QUALITY ASSURANCE -- NON-CONFORMANCE REPORT

Location: Changxing Island, Shanghai, P.R. China **Report No:** NCR-000889
Prime Contractor: American Bridge/Fluor Enterprises, a JV **Date:** 09-Nov-2010
Submitting Contractor: Zhenhua Port Machinery Company, Ltd (ZPMC), Changxing Island **NCR #:** ZPMC-0851

Reference Description: QA found non-approved drilled holes on the service platform electrical panel support SP6.

NCR PROPOSED RESOLUTION

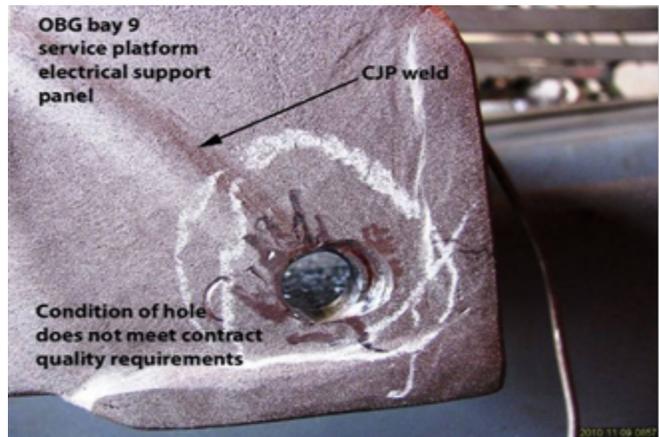
- During Quality Assurance (QA) random visual inspection after grit blasting of OBG Service Platform Electrical Panel Support, this Caltrans QA Inspector observed the following issues:
- ZPMC has drilled approximately 15 to 20 holes which were not specified on the approved shop drawings.
 - The additional holes were drilled in a service platform electrical panel support SP6.
 - These holes were added without the Engineer’s approval.
 - Additionally, The holes do not appear to meet the quality requirements of the contract documents.
 - A number of the holes have been drilled into fillet and CJP welds.
 - The approved shop drawings are identified as SPEP1-A.
 - OBG Service Platform Electrical Panel Support components are located at bay#9.

Reference Resolution: ZPMC has repaired the misdrilled holes which overlap with existing welds. Attached is the repair report as well as the NDT performed after to show that it is acceptable.

The proposed resolution is acceptable. This NCR is considered closed.

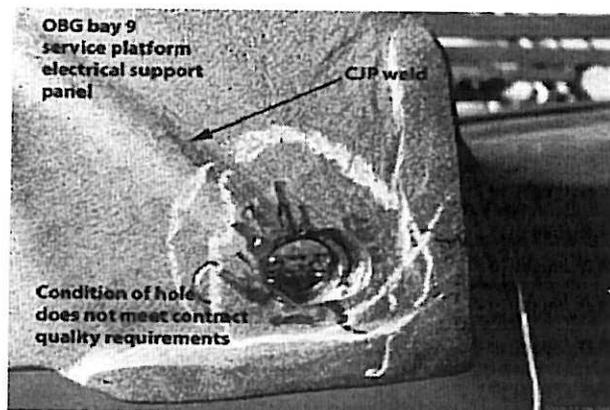
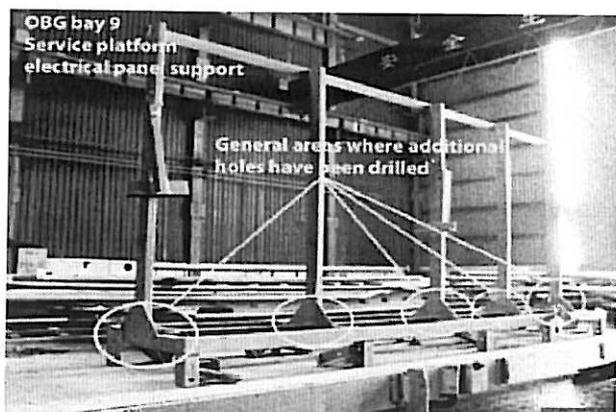
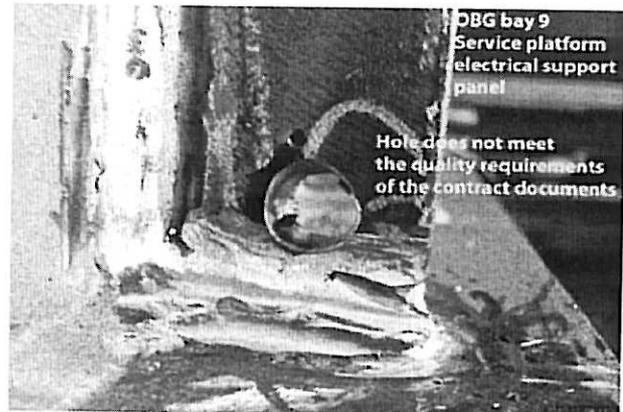
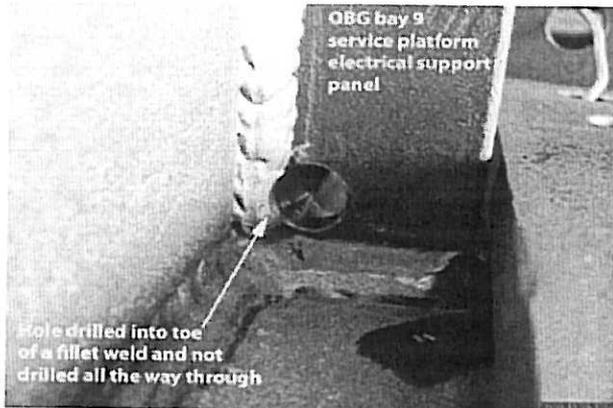
During Quality Assurance (QA) random visual inspection after grit blasting of OBG Service Platform Electrical Panel Support, this Caltrans QA Inspector observed the following issues:

- ZPMC has drilled approximately 15 to 20 holes which were not specified on the approved shop drawings.
- The additional holes were drilled in a service platform electrical panel support SP6.
- These holes were added without the Engineer's approval.
- Additionally, The holes do not appear to meet the quality requirements of the contract documents.
- A number of the holes have been drilled into fillet and CJP welds.
- The approved shop drawings are identified as SPEP1-A.
- OBG Service Platform Electrical Panel Support components are located at bay#9.

As agreed with you yesterday, holes drilled into the fillet and CJP welds of the service platforms' electrical panel frames shall be repaired per an approved procedure with 100% VT and 100% MT performed on the repairs, and any damaged galvanizing shall be repaired in conformance with the Contract requirements.

As for holes not drilled into the welds, these holes are acceptable to remain, provided they can be brought into conformance with the Contract requirements as identified in the NCR and the damaged galvanizing repair requirements.

项目名称 Project Name	美国海湾大桥 SFOBR	部件图号 Drawing No	SPEP1-A	报告编号 Report No.	B-WR16908
合同号 Contract No.:	04-0120F4	部件名称 Items Name	6#服务平台电器支架	NDT报告编号 Report No.of NDT	NA
项目编号 Project No.:	ZP06-787

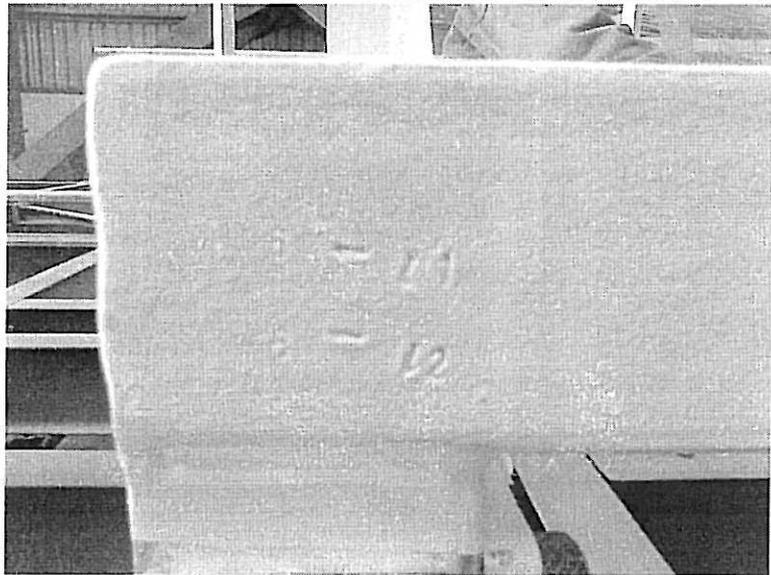
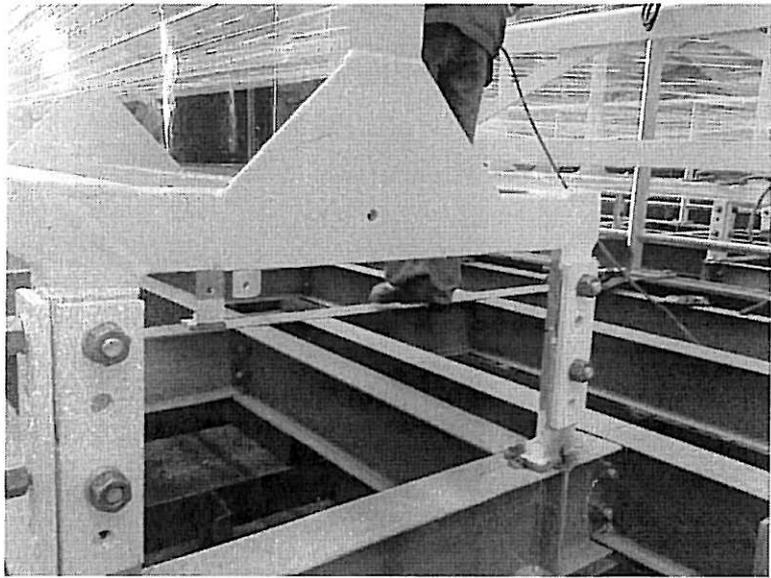
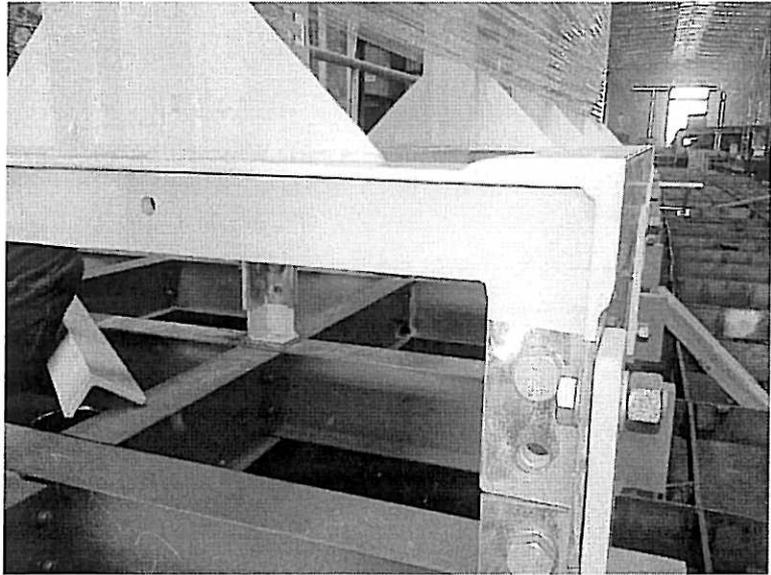
经检查发现: 施工队在对电器支架角钢开漏锌孔时, 将孔开在了焊缝处, 共计8处。

After inspection, we found they have added extra holes to the Service Platform cable supports on the welding area. The total number is 8.

1. 按照焊接返修工艺规程 (WPS) 打磨缺陷区域至光滑;
2. 准备一个正确的接头形式, 具体参见返修的WPS;
3. 对返修区域作100%MT和100%VT检查;
4. 如果仍发现有缺陷, 通过打磨的方法去除所有缺陷以确认缺陷完全被清除, 并重复第三步以确认缺陷完全被清除;
5. 将杂物以及MT检测遗留的残留物清理干净;
6. 根据批准的焊接返修工艺规程 (WPS) 进行预热及焊接;
7. 将焊接区域打磨至与母材平齐;
8. 对返修区域作NDT检查。

1. Grind the repair area to a smooth finish according to the approved repair WPS.
2. Prepare the joint according to the approved WPS.
3. Perform 100%MT and 100%VT of the repair area.
4. Remove all defects by grinding to ensure all defects are completely removed if defects still exist, and repeat "step 4" to assure complete removal of all defects if necessary.
5. Clean the repair area of all loose debris including MT powder.
6. Preheat and weld according to the approved WPS.
7. Grind the weld flush after welding.
8. Perform NDT of the repair area.
